# Team Update 07

Image from the laminated field layout on left, image from actual field on right

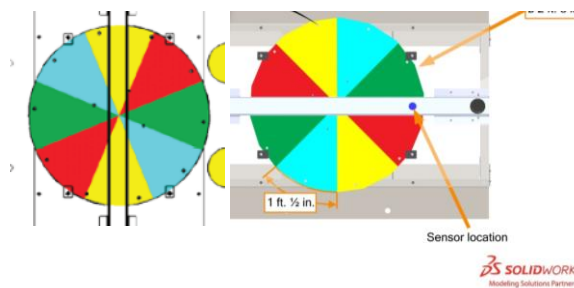
FIRST Choice Round 2 orders continue to ship (we thank you for your patience!). For those of you who have received them, you've probably noticed a bonus item included in each shipment; a laminated field layout w/ dry erase marker. Thank you to Piedmont Plastics for the strategic donation. We want to let you know that the color pattern on these boards (shown on the left below, clockwise: Y, R, G, and B) are the opposite of the actual field (shown on the right below, clockwise: B, G, R, and Y).
